PLANNING COMMISSION MEETING
Tuesday April 9, 2024
7 PM

PLANNING REPORT

TO: Adam Nafstad
FROM: Alan Brixius
DATE: April 1, 2024
RE: Learning Care / Everbrooke Daycare PUD/CUP
FILE NO: 163.06 24.02

SITE PLAN
EVERBROOK ACADEMY
ALBERTVILLE, MINNESOTA

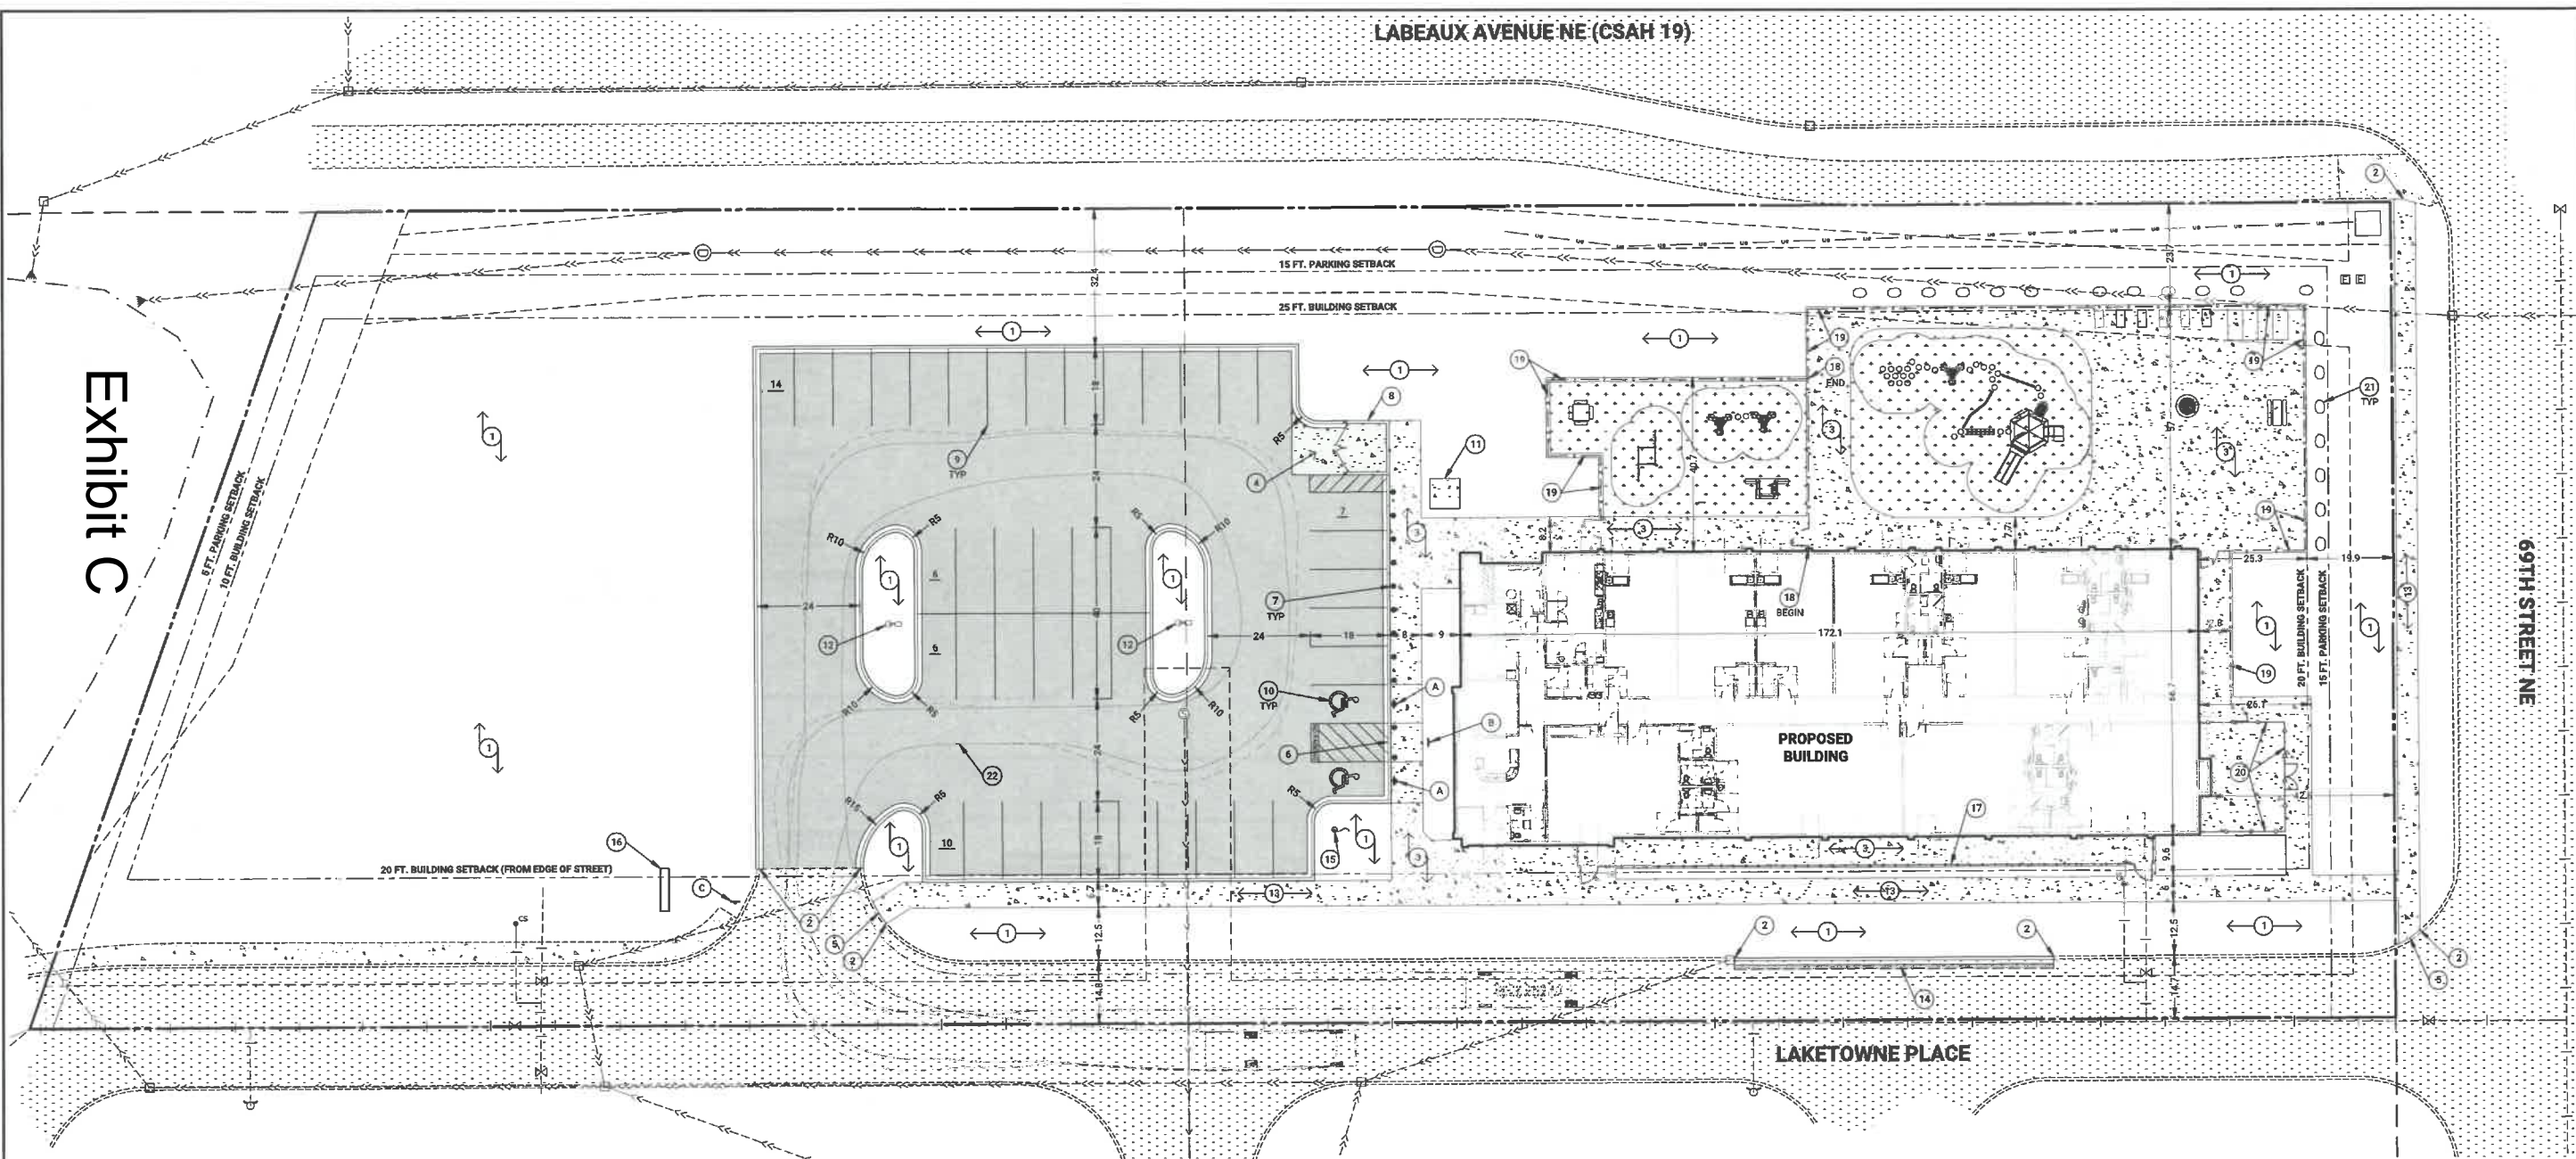
The parking lot shows bituminous surfacing, concrete curbing, and striping meeting the City zoning standards. Parking spaces are required to be 20 feet in length and 9 feet in width. The site plan shows the parking stalls dimensioned at 9 feet in width and 18 feet. The Site Plan must be revised to provide for the 20-foot parking stall length.

The play area is proposed on the west side of the building. Play area is surrounded by a six-foot-tall white vinyl privacy fence. The play area meets the building setback along CR.19 but extends into the required front yard setback from 69th Street. Staff recommends the play area be shifted south to provide a 25-foot setback from the north lot line.

3. The parking lot be shifted west to provide a 10 foot landscape area along the east side of the parking lot to allow landscape screening of the parking lot. The parking stalls shall be revised to provide a 20 foot stall length.

Exhibit G

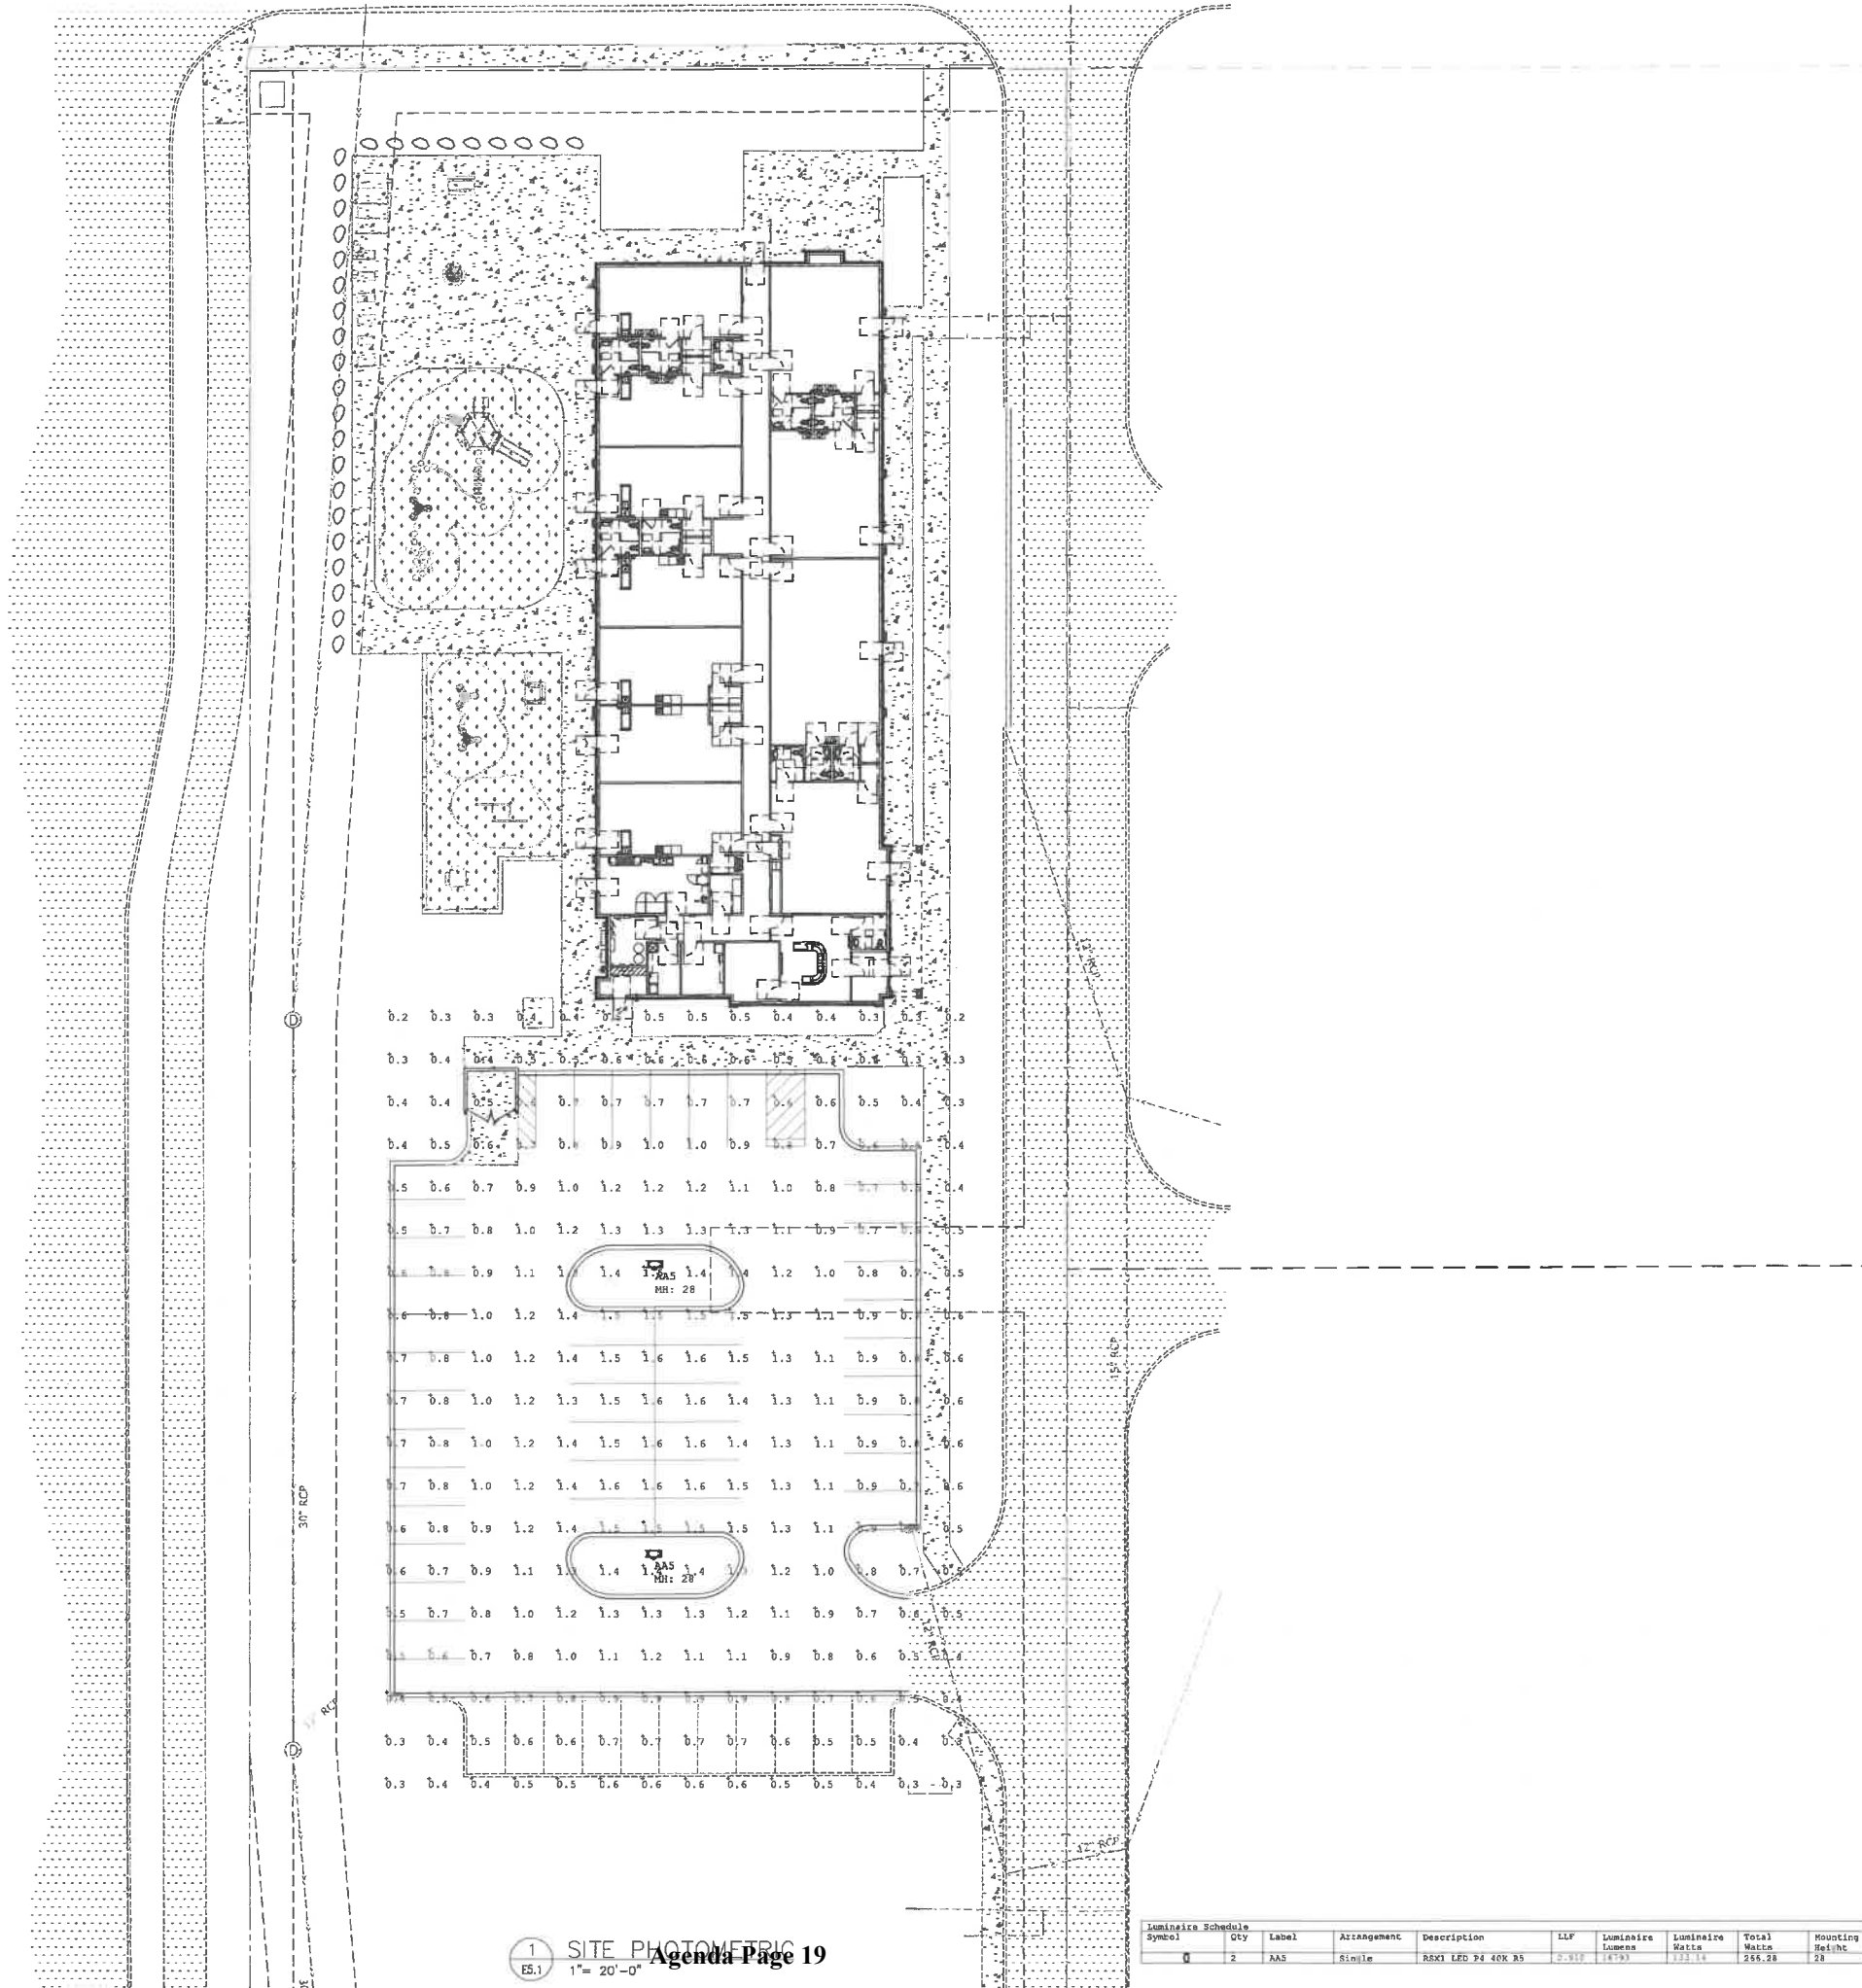
Outdoor Lighting. The provided photometric plan shows that lighting levels over the parking lot meeting City standards at the property lines. The photometric plan must be expanded to illustrate the light level produced by the wall mounted light fixtures. Applicant shall provide cut sheets of the proposed exterior fixtures both wall mounted and freestanding to demonstrate a 90-degree cut off and screened light source. The Freestanding light poles shall not exceed a height of 30 feet.

4. Applicant shall provide a design elevation of the trash enclosure for City approval.
5. The photometric plan shall be revised to illustrate the light levels around the building pertaining to the buildings wall mounted light fixtures. Detail cut-sheets of proposed wall mounted and freestanding light fixtures showing that they area 90 degree cut-off and shield light source. The lighting plan shall show the pole height and design of the freestanding lights.
